Riverside Energy Park, Belvedere

Planning Inspectorate reference: EN010093

National Infrastructure Project Development Consent Order application – Deadline 7 Representations

Purpose of this document

Figure 5.1: Electricity generation by fuel source

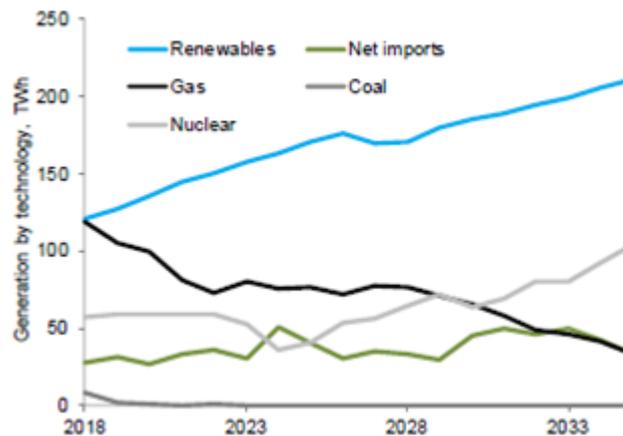
4.11. In the period since 2014 when the Report was published, this effect has been evidenced in the reported energy generation figures. In April 2019, BEIS published its updated energy and emissions projections³. The document included the graph shown as Figure 5.1 below. From this it is clear that – at the time of publication in 2019 – renewable generation has already overtaken gas in terms of its proportionate contribution to the UK’s total generation capacity. Since the contribution for renewables is shown as steadily increasing, whilst that of gas CCGT is decreasing, this suggests that new generation capacity coming online is now likely to be renewables, rather than gas. The graph shows a steady decline in gas CCGT out to 2035 – by which point the contribution from gas to the UK’s total electrical generation is anticipated to be less than a third.

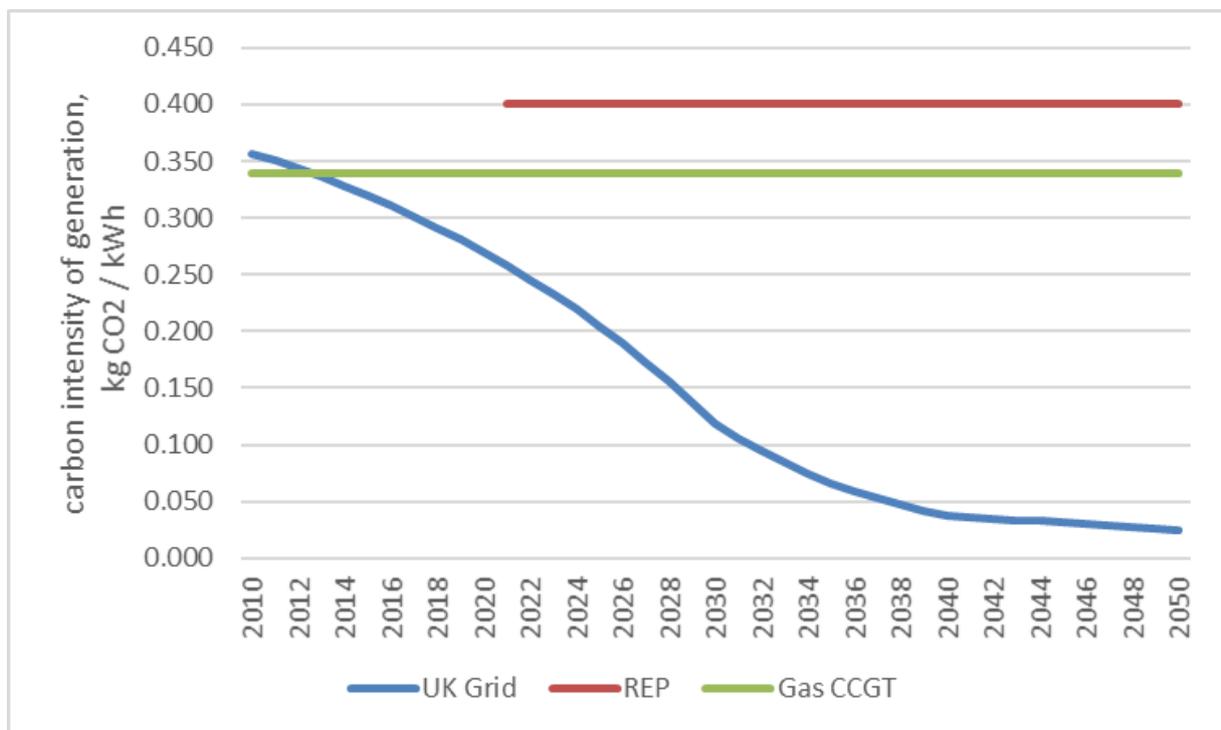
4.13. Furthermore, other Government sources indicate that Government is reflecting the current UK generation mix in its advice to business and other stakeholders. The BEIS website contains energy conversion factors for business carbon reporting⁴ that recommend the use of a UK electricity carbon equivalent of 0.28307 kg CO₂e/kWh in 2018. This aligns with the Eunomia report, Deadline 3 GLA Written Summary of Oral Case Appendix 3 and contrasts with the 0.4 kg CO₂/kWh (ie CCGT) used by the Applicant for the REP. This confirms that the facility will generate electricity that is of a higher carbon intensity than that generated by the UK electricity grid in 2010. By the time the facility is likely to start generating electricity, the carbon intensity of the grid will be much lower, in the order of 0.25 kg CO₂e per kWh electricity. Over time, the difference in carbon intensity between electricity generated at the REP and that of the grid will widen, as is shown in the graph below taken from the Eunomia report.
